Project	IEEE 802.16 Broadband Wireless Access Working Group < http://ieee802.org/16 >	
Title	Action Item from Session #48: MAC messages text update for credit token based coexistence protocol	
Date Submitted	2007-05-08	
Source(s)	David Grandblaise Motorola Labs Parc Les Algorithmes Commune de Saint Aubin 91193 Gif sur Yvette, France	Voice: +33 (0)1 6935 2582 Fax: +33 (0)1 6935 4801 mailto: david.grandblaise@motorola.com
Re:	Working Group Letter Ballot #24a for IEEE P80216h/D2a	
Abstract	During sessions # 47 and # 48, several comments (2127, 2152L, 2153L) were made to update and clean up text related to MAC messages for the credit token based coexistence protocol. This contribution provides some text remedy proposals for these comments, and consolidates the previous preliminary contribution [3].	
Purpose	Action Item from Session #48: MAC messages text update for credit token based coexistence protocol

Action Item from Session #48: MAC messages text update for credit token based coexistence protocol

Figure hb: Inter system over the air communications messages for CT-CXP operations

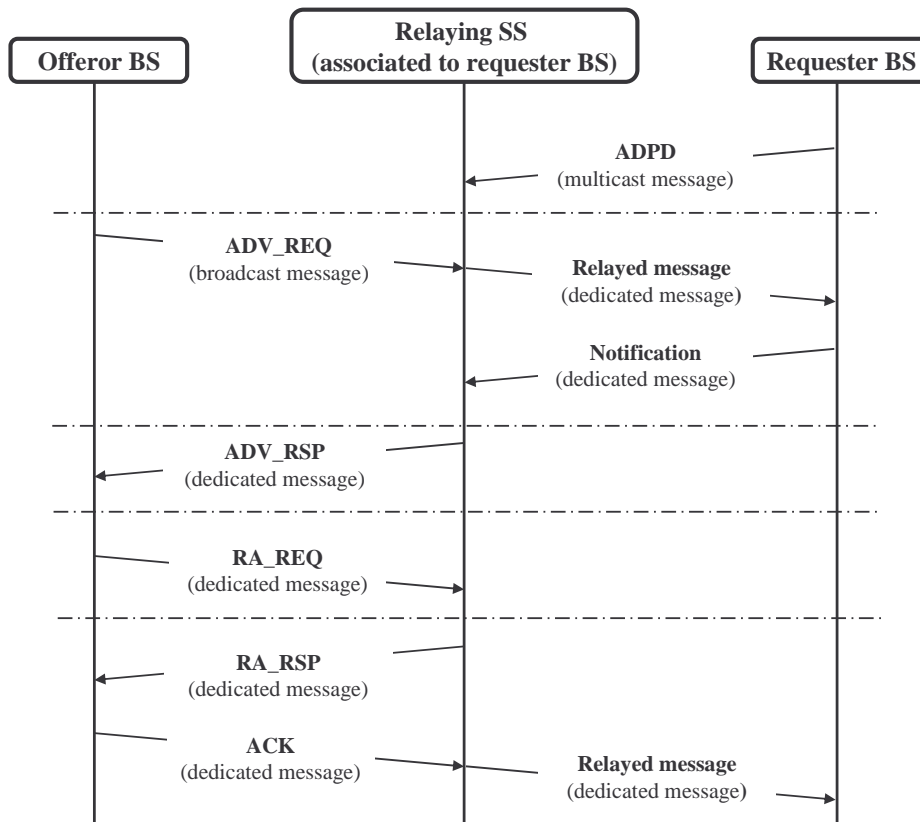
[Create a new clause 15.x as indicate:]

15.x Inter-system over the air communications

15.x.1 CT-CXP

Figure hb describes the over the air communications messages between the offeror and requester for CT-CXP operations. The messages between the offeror BS and requester BSs are conveyed through SS(s) acting as relay between the offeror and requester BSs. Each relaying SS is associated to the requester BS and is in the overlapping coverage of the offeror and requester BSs. The relaying SS can receive and decode messages from both its serving BS (requester BS) and the foreign BS (offeror BS), and can send transmit message to both offer or and requester BS.
